Appl. No. 09/842,778 Amendment dated March 24, 2004 Reply to Office Action of January 15, 2004

Amendments to the Drawings:

REMARKS/ARGUMENTS

Appln. No. 09/842,778 Amdt. dated March 24, 2004 Reply to Office Action of January 15, 2004 Annotated Sheet Showing Changes

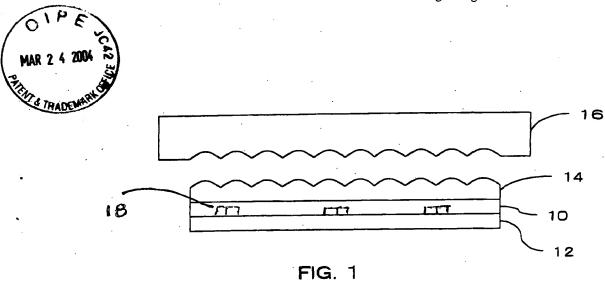
The Patent Office further asserts that none of the figures illustrate a front panel having a plurality of electrodes. Figure 1 has been modified to include a plurality of electrodes 18. No new matter has been added.

The attached sheets of drawings include changes to Figure 1, and newly added Figure 5. Figure 1 replaces the original sheet of Figure 1. In Figure 1, previously omitted element 18 has been added.
